Access Compliance Report

Public Rights-of-Way

Intersection ID: 28718	Main Street: DEARMON_RD	Cross Street: HAMPTON_PLACE_DR	Location: S
ADA ID: 84FF61AF0EFB	Ramp Type: Perp	Initial Pass/Fail: Fail	Overall Compliance: No
Severity Score: 21.25			
Codes/Mitigation Info/Possible Solution		Field Measurements/Component Compliance

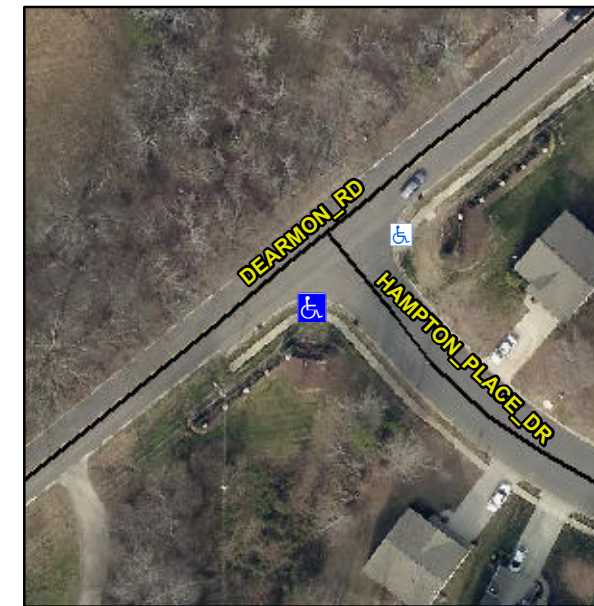
R304.5.1, R304.2.2

Compliance	Description	Data	Compliance	Description	Data
N/A	Ramp Length (in)	48.0	No	Ramp Slope (%)	11.6
No	Ramp Width (in)	40.0	Yes	Ramp XSlope (%)	1.2
N/A	Flare Type LT	N/A	N/A	Flare Type RT	N/A
N/A	Flare Slope LT (%)	N/A	N/A	Flare Slope RT (%)	N/A
N/A	Flare Traversable LT?	N/A	N/A	Flare Traversable RT?	N/A
N/A	Landing Length (in)	N/A	N/A	DWS Provided?	N/A
N/A	Landing Width (in)	N/A	N/A	DWS Contrast?	N/A
N/A	Landing Slope (%)	N/A	N/A	DWS Length (in)	N/A
N/A	Landing X Slope (%)	N/A	N/A	DWS Full Width?	N/A
N/A	Landing Curb? (Y/N)	N/A	N/A	DWS Offset (in)	N/A
N/A	Shared Landing?	N/A			
N/A	Gutter Ponding?	N/A	N/A	Gutter Slope (%)	N/A
N/A	Gutter Lip Ht (in)	N/A	N/A	Gutter X Slope (%)	N/A
N/A	Painted X Walk1?	No	N/A	Painted X Walk2?	N/A
	X Walk 1 Direction	To NE		X Walk 2 Direction	N/A
N/A	X Walk 1 Width (in)	N/A	N/A	X Walk 2 Width (in)	N/A
	X Walk 1 Slope (%)	2.7		X Walk 2 Slope (%)	N/A
	X Walk 1 X Slope (%)	0.5		X Walk 2 X Slope (%)	N/A

Remove & Replace Entire Ramp.
